DESIGN <i>[Signature]</i>	DRAWN BY <i>[Signature]</i>	DART AEROSPACE LTD HAWKESBURY, ONTARIO, CANADA	
CHECKED <i>[Signature]</i>	APPROVED <i>[Signature]</i>	DRAWING NO. DEO 9251	REV. A SHEET 1 OF 1
DATE 03.02.19		TITLE BRACKET MODIFICATION	SCALE NTS
A	03.02.19	NEW ISSUE

## DART ENGINEERING ORDER

TO AMEND BHA/DRA/358-02-01 REV. F

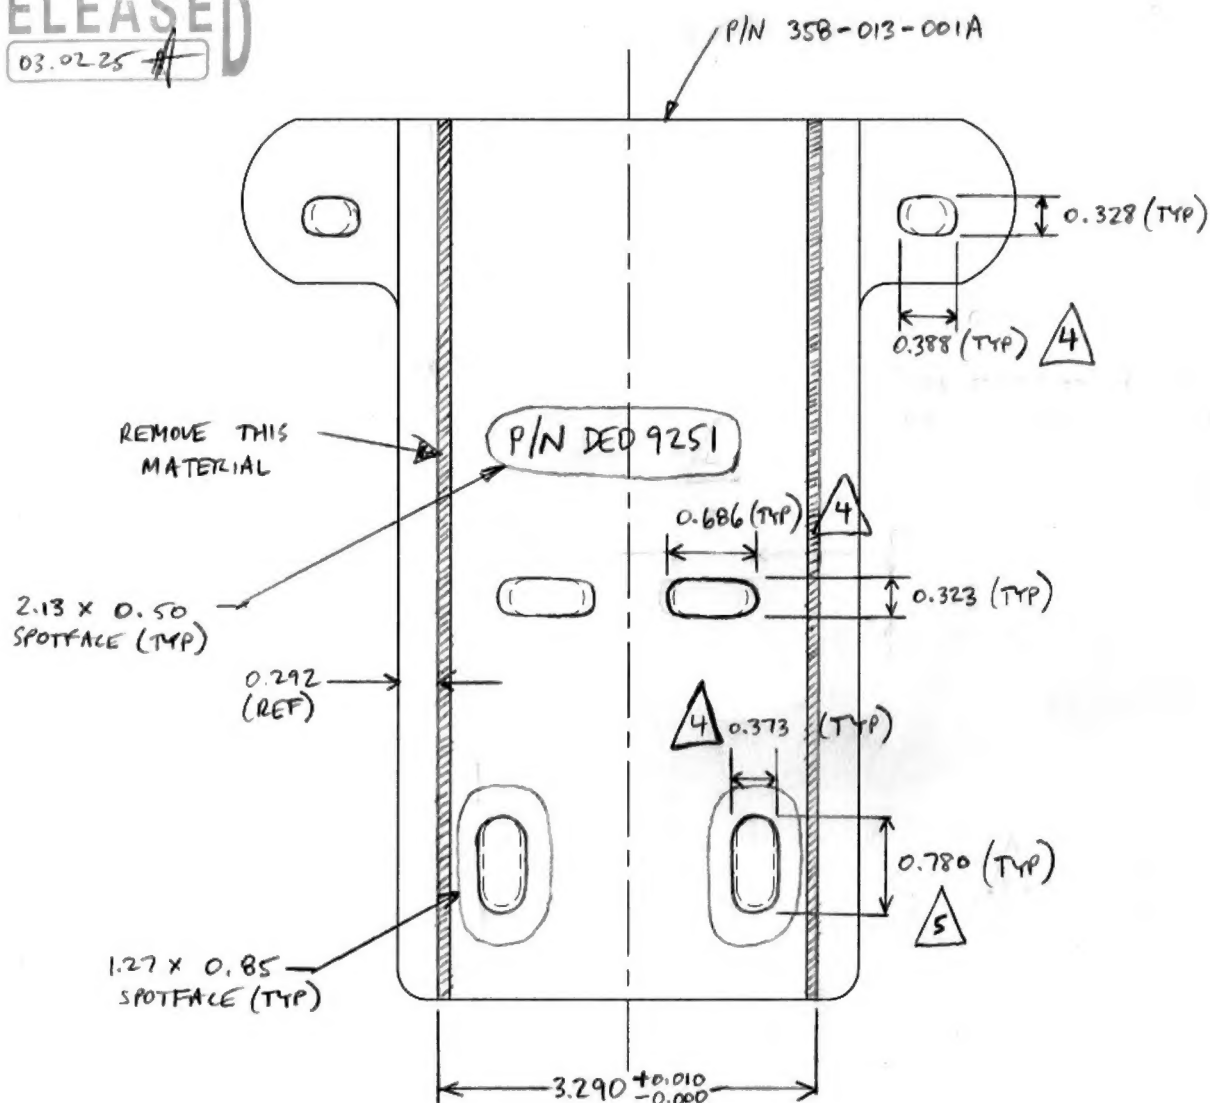
- NOTES:
- 1) IDENTIFY AS DEO 9251 AFTER MODIFICATION
  - 2) POWDER COAT WHITE (4.3.5.1) PER QSI DQS 4.3 AFTER MODIFICATION
  - 3) ALL SLOT DIMENSIONS ARE  $\pm 0.010 / - 0.000$
  - 4) ADD 0.030 TO EACH SIDE OF EXISTING HOLE OR SLOT TO GET THIS DIM
  - 5) ADD 0.030 TO BOTTOM SIDE TO GET THIS DIM
